**August 28, 2012
Medway Planning and Economic Development Board
155 Village Street
Medway, MA 02053**

Norwood Acres Definitive Subdivision Plan - 61 Summer Street - Public hearing Continuation

Bay Oak Definitive Subdivision Plan, 104 Fisher St – Public Hearing Continuation

Site Plan Modification: 45 Milford Street/45 Place

Stone Trench Stormwater Infiltration

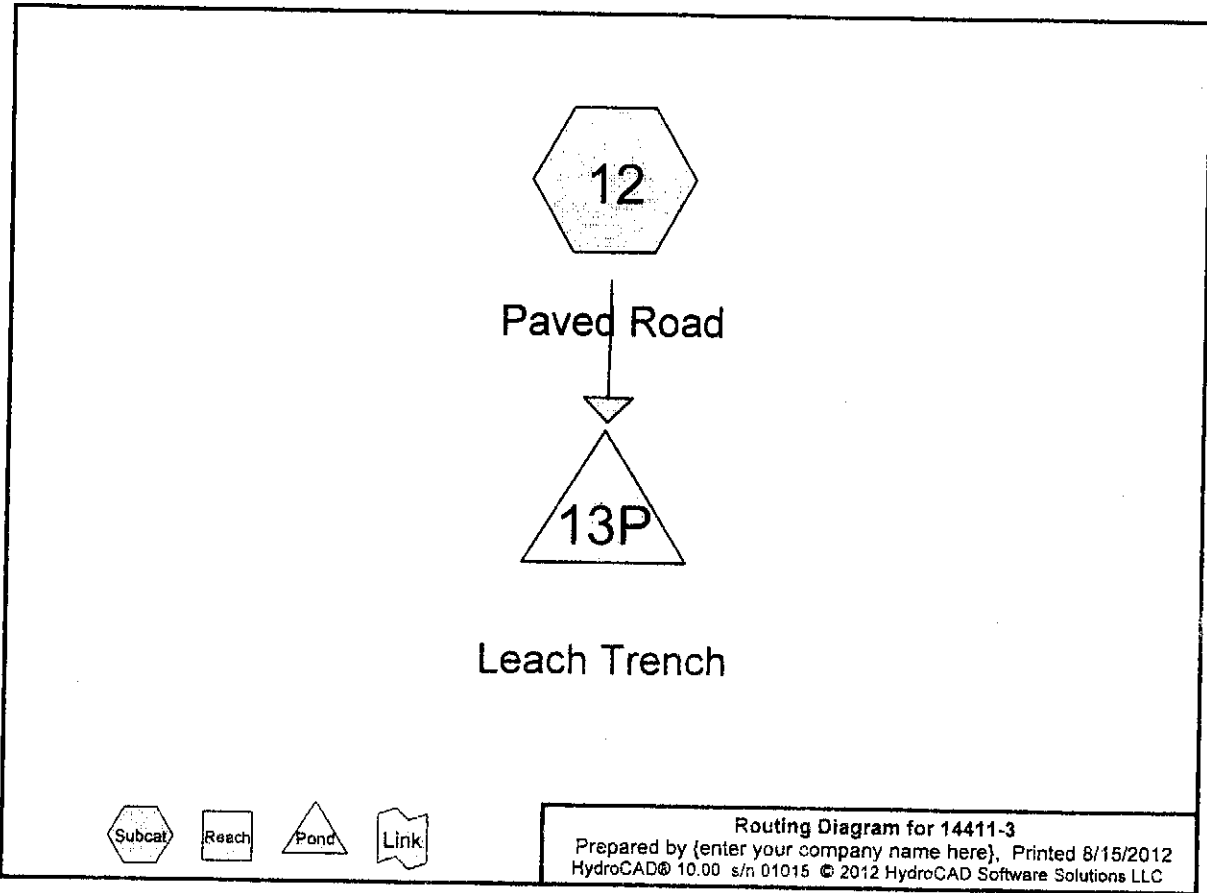
Rob Truax of GLM Engineering indicated that there was a minor change. It was the calculations on the trench drain. This was for mitigation. The width was increased. The cross-section was also changed. There was fabric put in as suggested.

The calculations indicate that the stone drainage trench will provide sufficient recharge capacity to accommodate the increase in volume of runoff generated from the proposed roadway. Therefore, based on the calculations there will be no increase in stormwater runoff towards Fisher Street.

PROPOSED NORTH ELEVATION

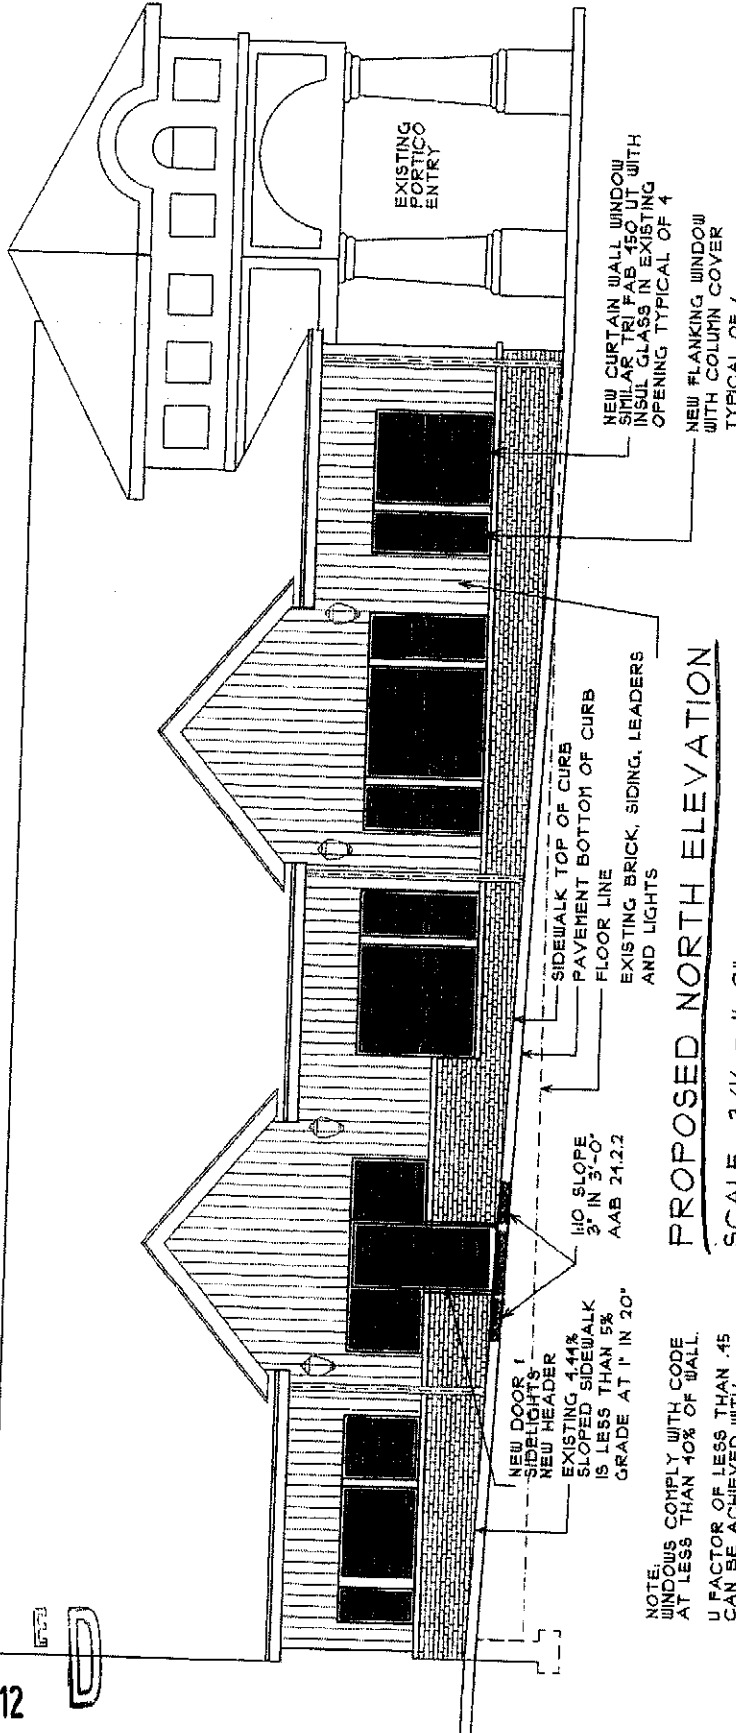
Mr. Paul Yorkis was present on behalf of the property owner to speak about the modification. He distributed a revised proposed elevation plan. The two issues include:

1. Amount of natural light coming into potential retail spaces. The approved plan has limited natural light.
2. Adding another point of public access to the building which will be compliant with handicap accessibility.

I'm in receipt of a request to modify the window area on the front section of the building located at 45 Milford Street. This section is the recently built addition. In my opinion, the proposed alteration is a non substantial change. Therefore, modification of the approved site plan will be required by the Planning Board prior to these proposed changes. Please contact me if you have any questions.

NOTE:
WINDOWS COMPLY WITH CODE AT LESS THAN 40% OF WALL.
U FACTOR OF LESS THAN .45 CAN BE ACHIEVED WITH PROPOSED TRI FAB SYSTEM
SIDEWALK MODIFICATIONS SHALL COMPLY WITH AAS SLOPE
LIFT OR RAMP TO BE PROVIDED AT INTERIOR OF UNIT.
